Application for Licence Amendment

Licence Number	L8721/2013/2
Licence Holder	Karara Mining Limited
ACN	070 871 831
File Number	2012/008499-1~13
Premises	<p>Karara Minesite Beneficiation Plant</p> <p>M59/644, M59/645, M59/721, G59/38, L59/99 and L59/109 PERENJORI WA 6620</p> <p>As defined by the Premises maps attached to the Revised Licence</p>
Date of Report	20 November 2023
Decision	Revised licence granted

This Amendment Report documents the assessment of potential risks to the environment and public health from proposed changes to the emissions and discharges during the construction and operation of the Dry Stack Tailings Storage Facility (dry-stack TSF) Expansion and associated works at the Premises. As a result of this assessment, Revised Licence L8721/2013/2 has been granted.

Figure 1: Construction plan of the dry-stack TSF perimeter expansion and subsequent lifts.

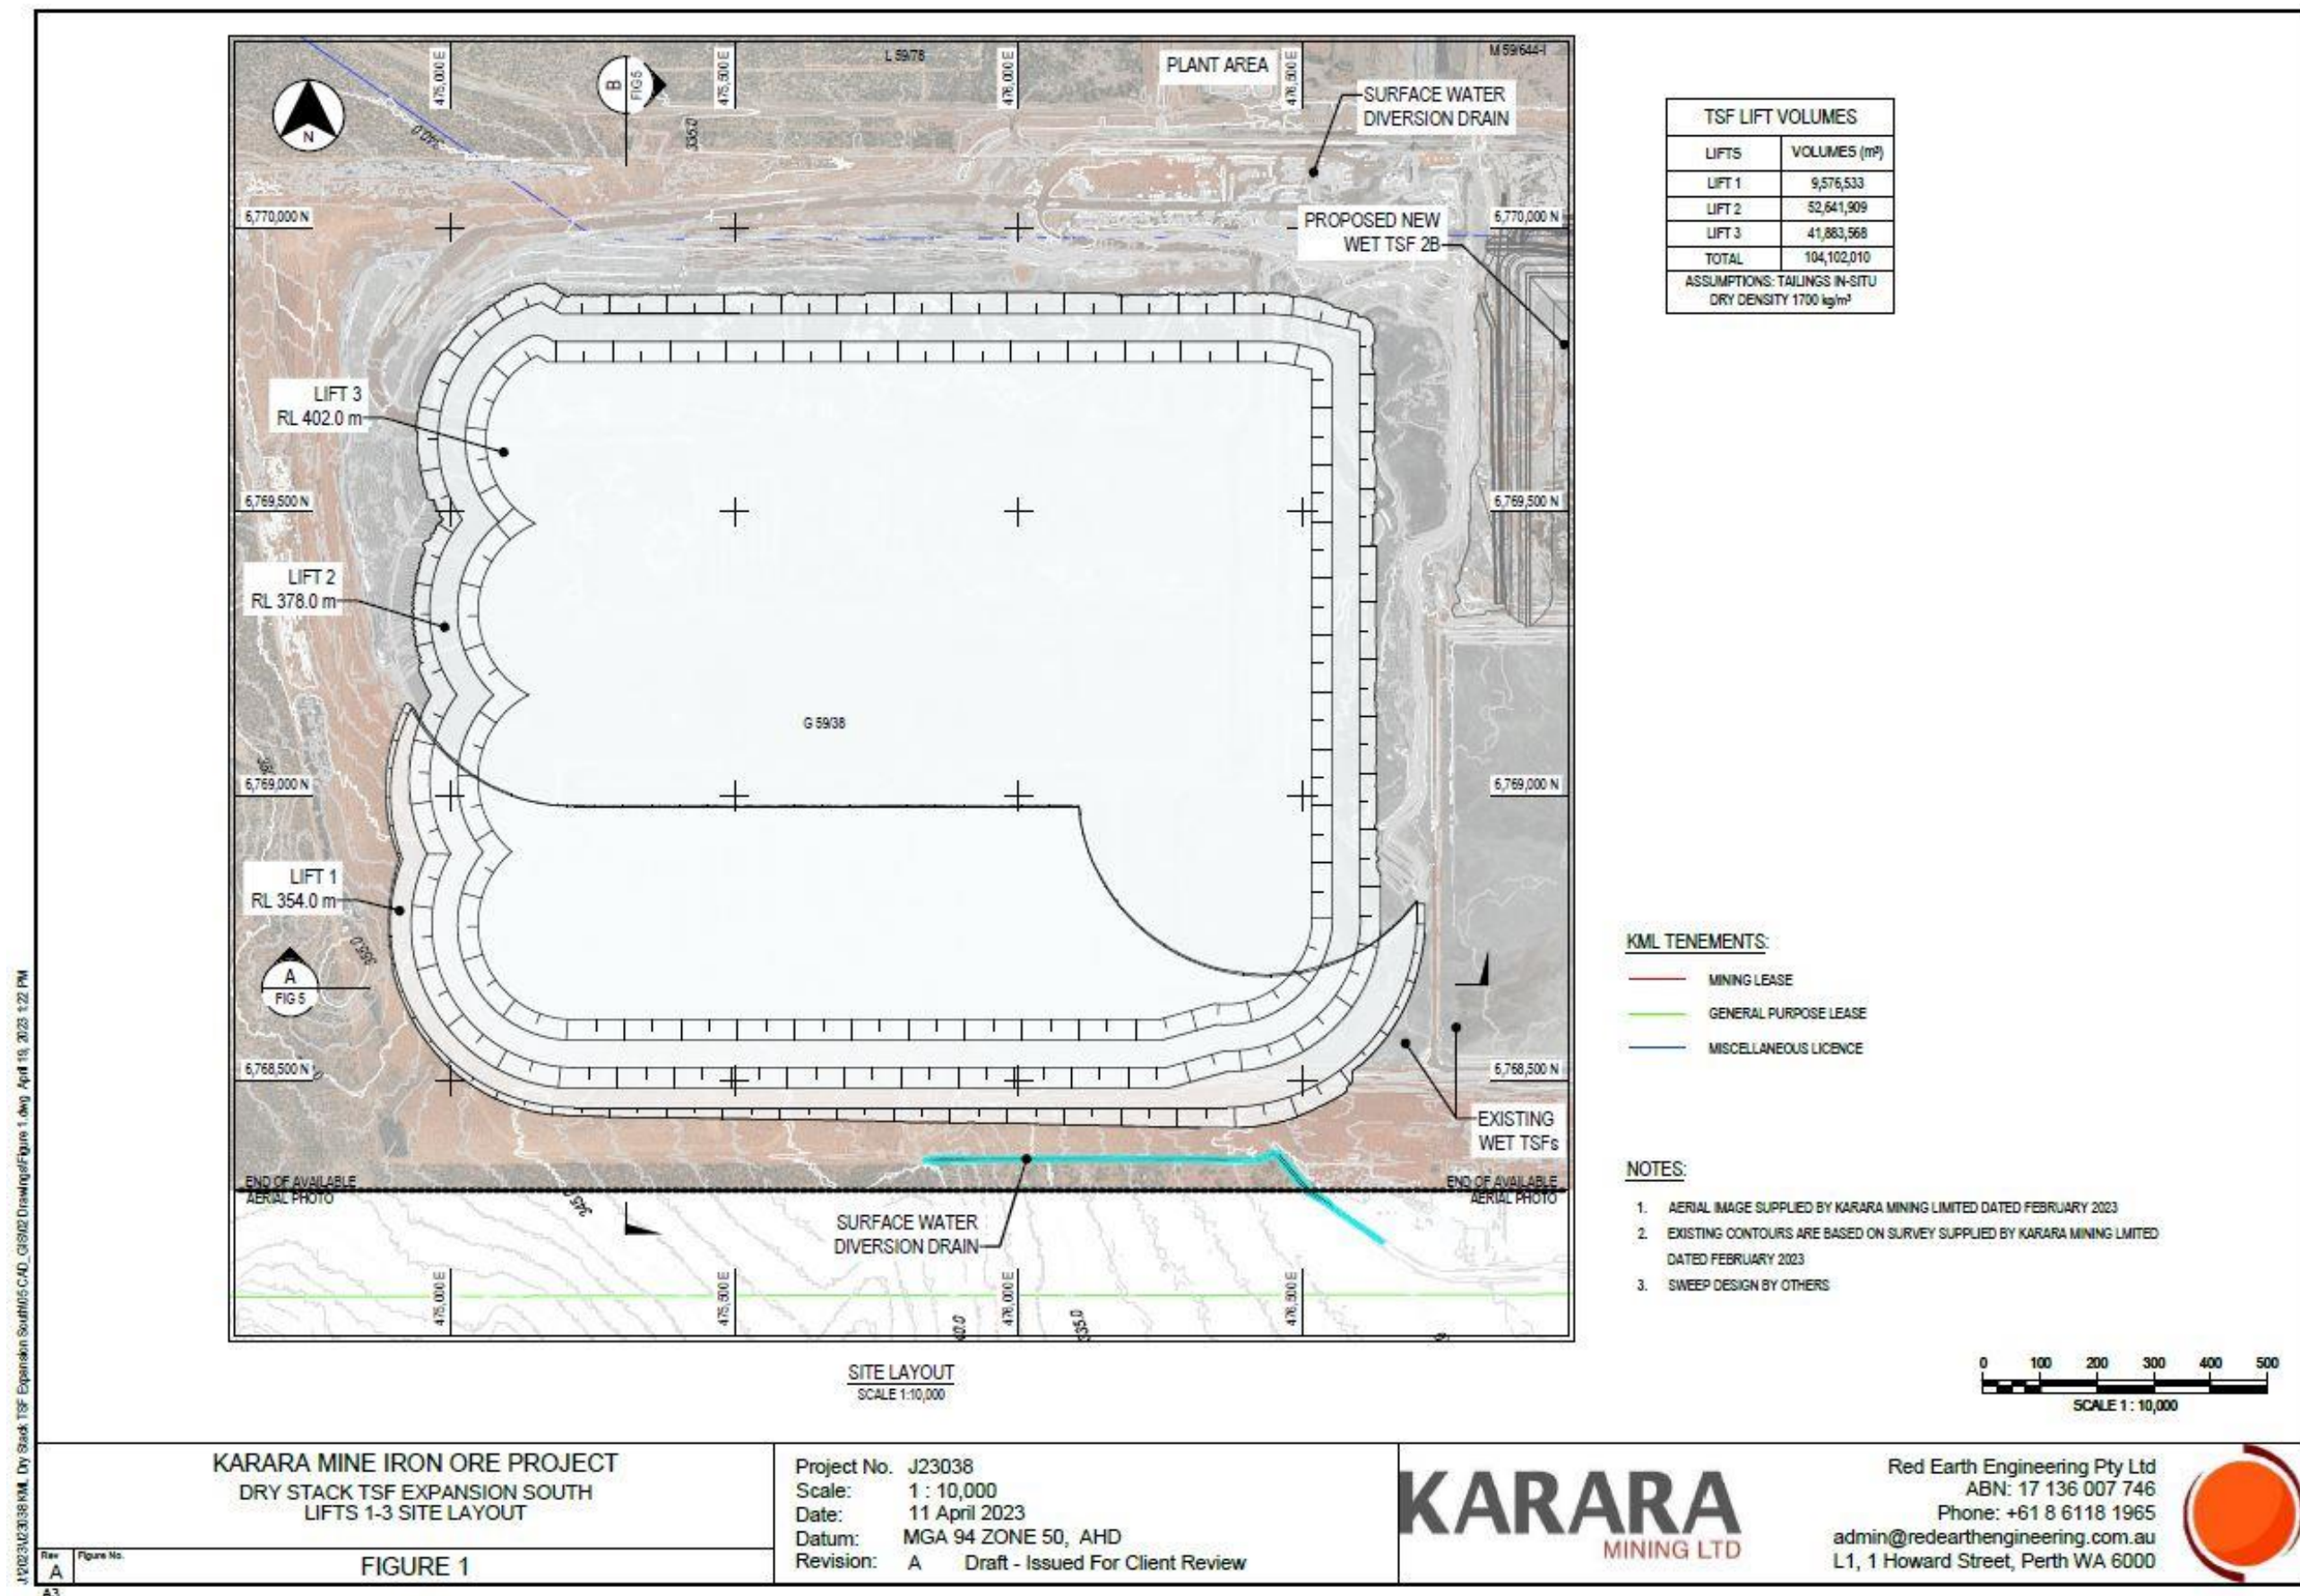
The dry-stack TSF has a current embankment height of RL 354 m (Figure 1). With storage heading towards capacity in September 2023, the Licence Holder has proposed to expand outwards the perimeter of the southern and eastern embankments of the dry-stack TSF. The expanded perimeter is proposed to be continued to be constructed out of dried tailings and built up from local ground level to RL 354 m (REE, 2021) (Figure 1).

Two additional lifts (lifts 2 and 3) are also proposed to be built on top of the existing and future perimeter expansion of lift 1, with dried tailings also delivered via mechanical stacking (Figure 1).

Figure 3: Graph of standing water levels from the Wet TSF 2A monitoring bores from the 2022 Annual Environmental Report

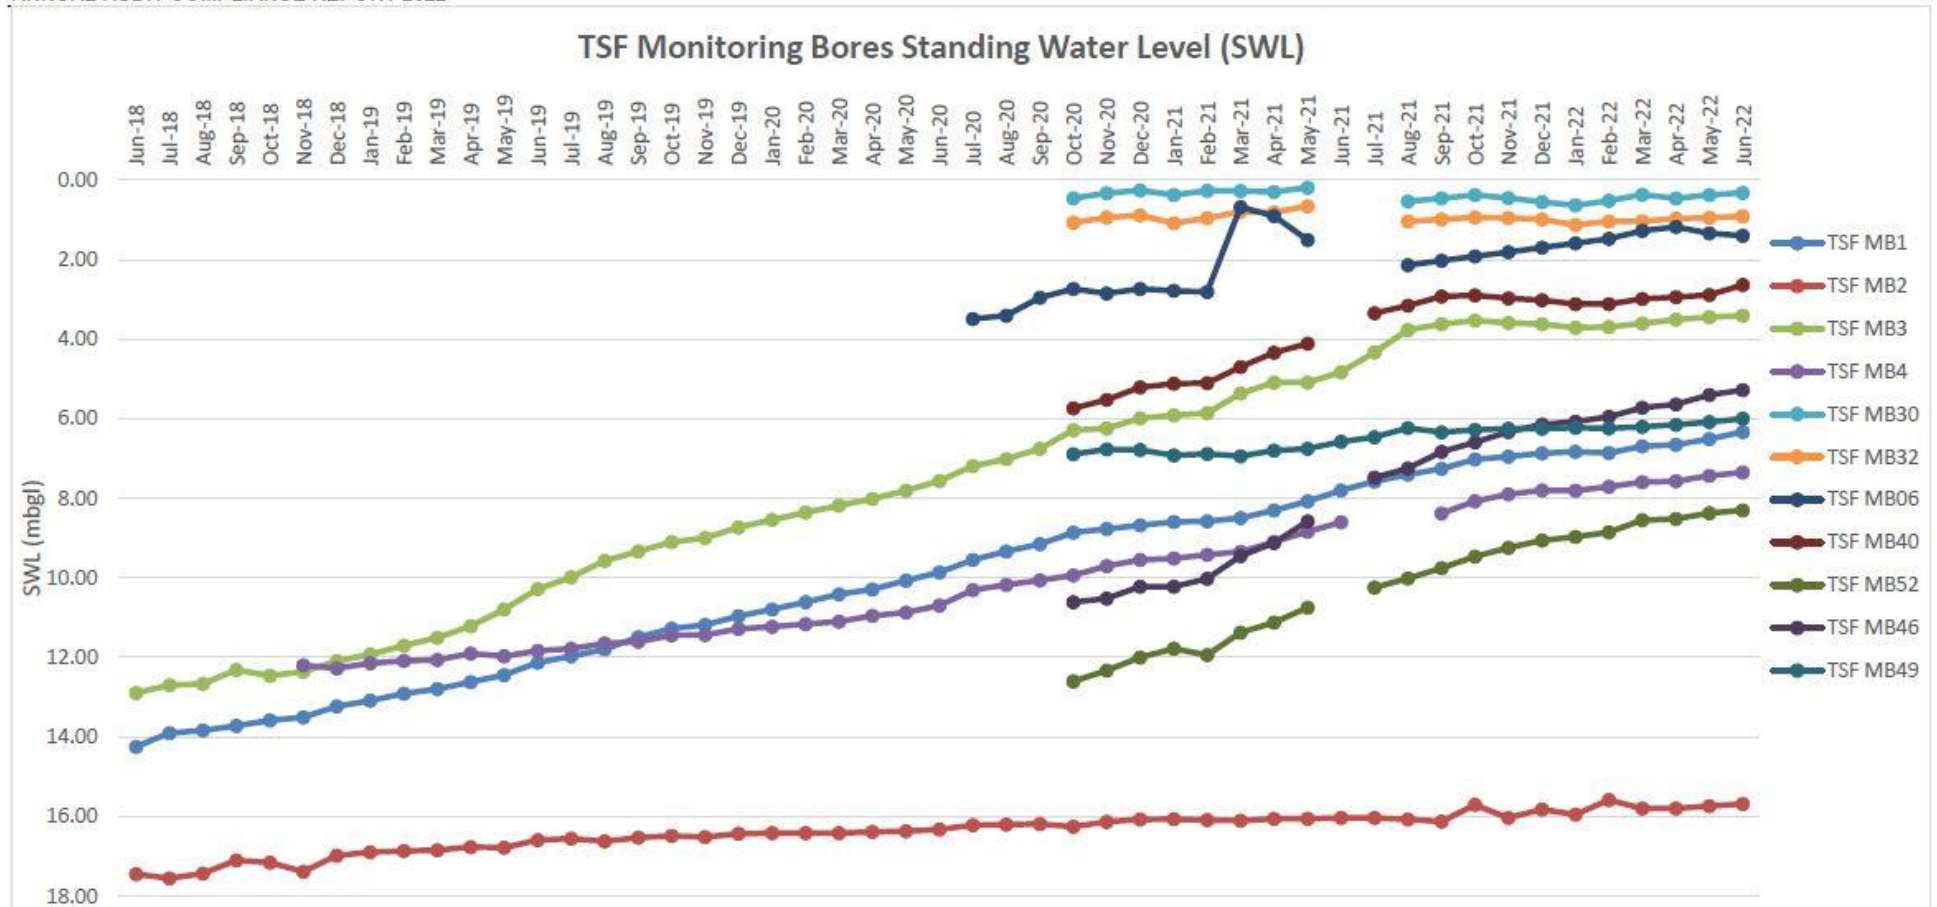
This condition was applied during a review of the 2022 Annual Environmental Report where it was noted that five monitoring bores were reporting standing water levels (SWL) within 4 m of ground level (Figure 2, Figure 3) and absence of SWL limits in the licence.

Regarding a recommended SWL, CSB advised the critical depth at which capillary forces are able to draw dissolved salts from the water table to the soil surface largely depends on soil texture. The critical depth for the capillary updraw of dissolved salts through the shallow silty-sand regolith near TSF2A is suggested to be about 2 m (Li *et al*, 2013).

Therefore, CSB recommended that a water table depth is maintained at a depth greater than about 2 m to limit the risk of soil salinisation and vegetation dieback taking place near (100 m east of) the Wet TSFs.

Figure 4: Graph of standing water levels from the Wet TSF 2A monitoring bores from the 2023 Annual Environmental Report

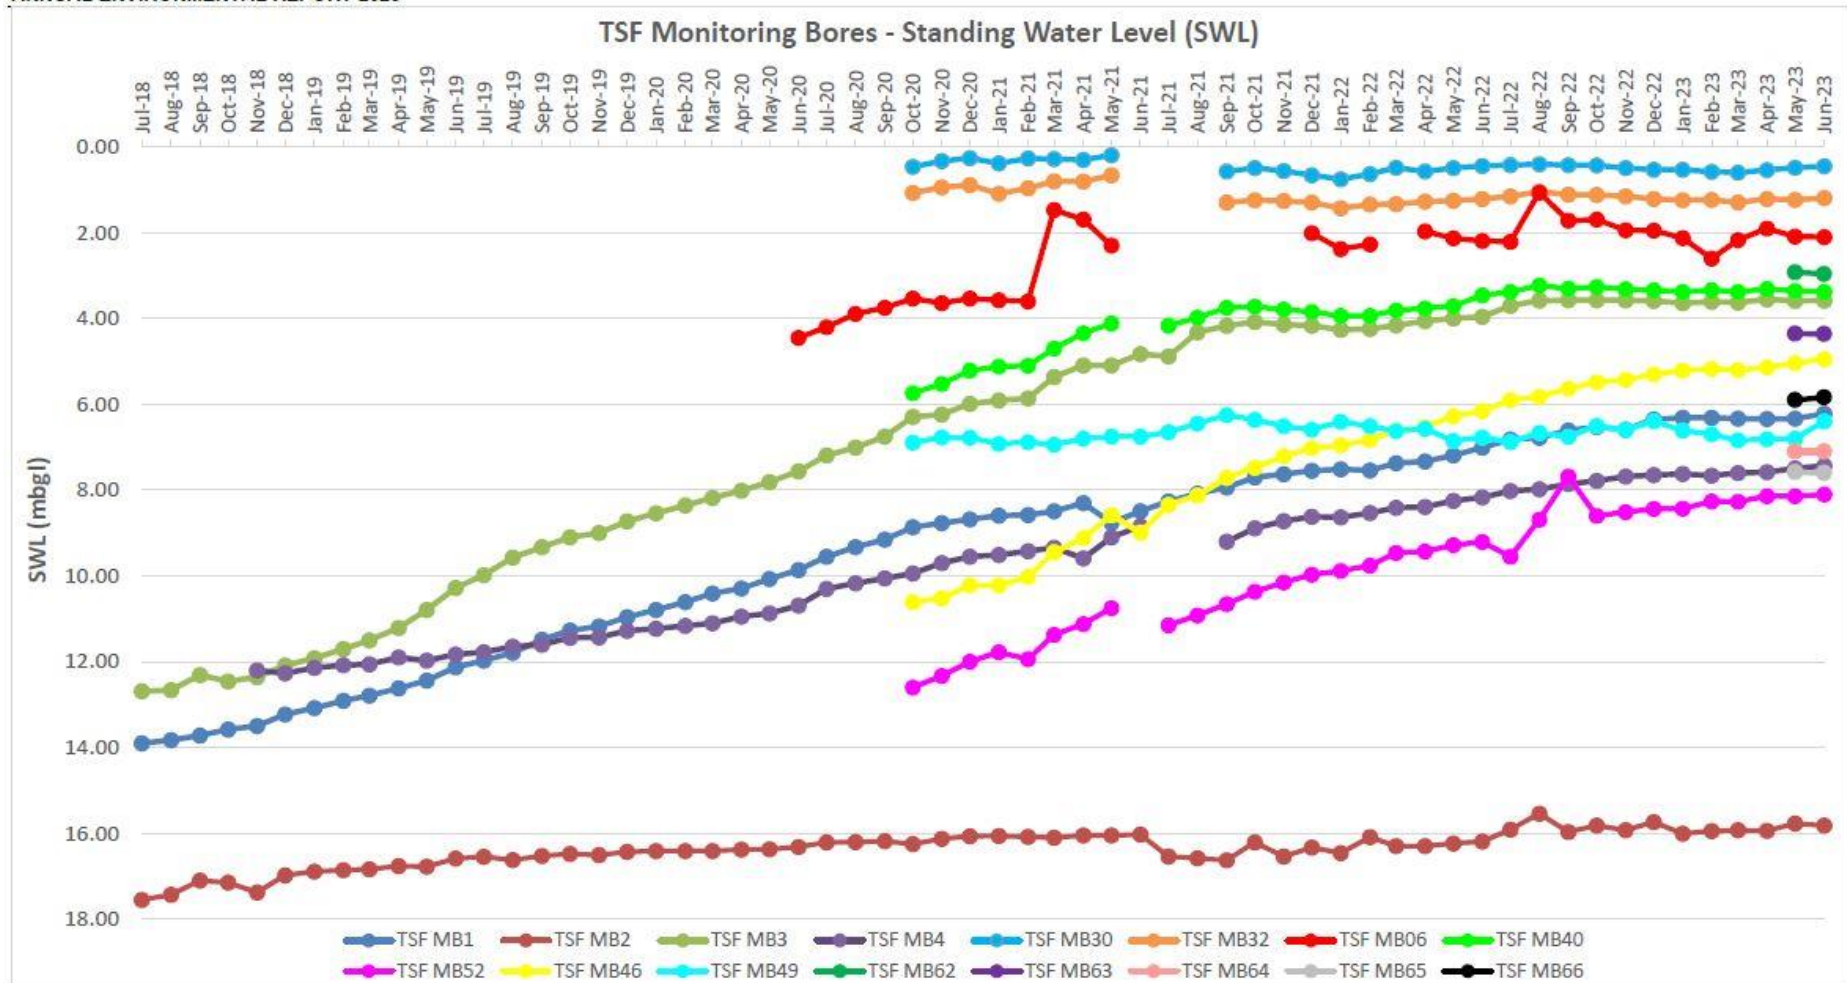
During this assessment, the 2023 Annual Environmental Report was also reviewed. There has

been reported a stabilisation of groundwater levels between 0 and 2 mbgl for TSF MB30, MB32, MB06, MB40 and MB03 (Figure 4).

The department has included conditions 32 to 34 to monitor the health of vegetation downstream of the nearest operational TSF (wet TSF 2A) and implement management actions if mass vegetation death due to high SWLs are observed.
